SERVICE BULLETIN

No.**292 77 2101**

ARRIEL 2 B - C - C-PM - C1 - S1

Subject: Electrical control system. Installation of three ECET N2 speed sensors.**Application of modification TU 101A (Alternative to modification TU 89).**

Capteurs de vitesse N2
N2 speed sensors

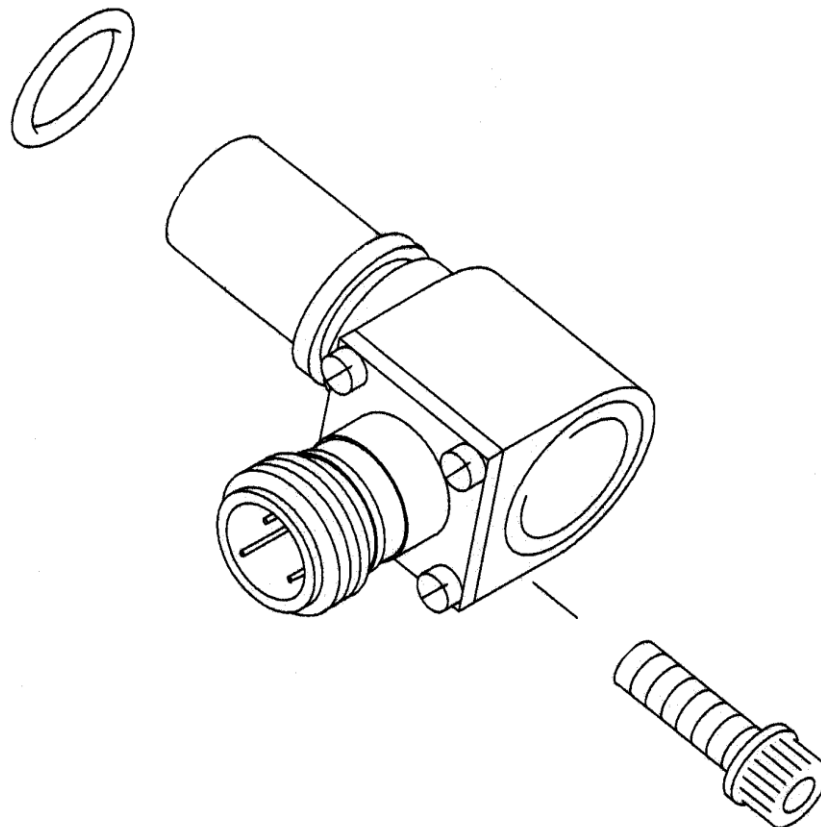
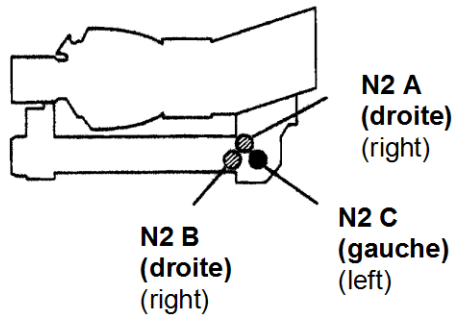
This modification consists of introducing, as an alternative use, ECET speed sensors with IN-LHC speed sensors.

New Part Number	Key	Qty	Description *	Old Part Number	Key	Qty
9 550 17 580 0	A	3	N2 speed sensor	9 550 16 867 0	C	3
